DEVELOPMENT APPLICATION ASSESSMENT REPORT

DA2021/0351

Responsible Officer:	Kye Miles	
Land to be developed (Address):	Lot 2 SP 102360, 2 / 4 Waiwera Avenue NORTH MANLY NSW 2100	
Proposed Development:	Demolition works and rebuilding and enlarging a dwelling forming part of a dual occupancy development	
Zoning:	Warringah LEP2011 - Land zoned R2 Low Density Residential	
Development Permissible:	No	
Existing Use Rights:	Yes	
Consent Authority:	Northern Beaches Council	
Land and Environment Court Action:	No	
Owner:	4 Waiwera Avenue Pty Ltd

1. Nature of the views affected

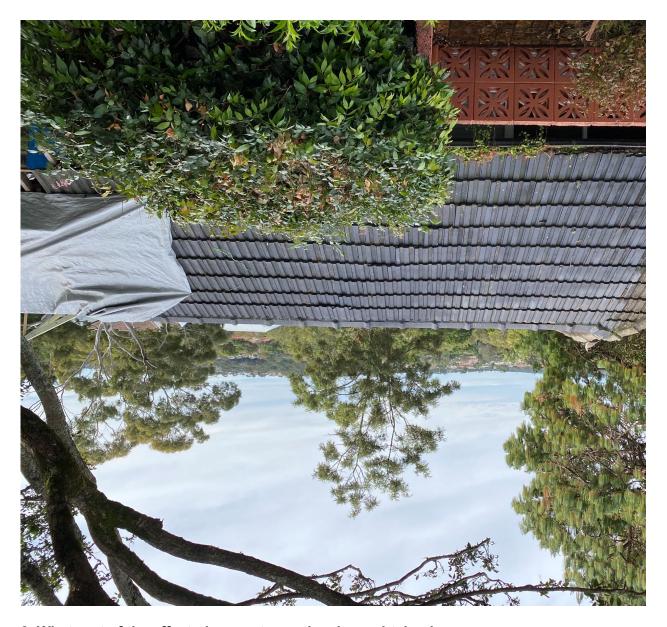
Comment to Principle 1:
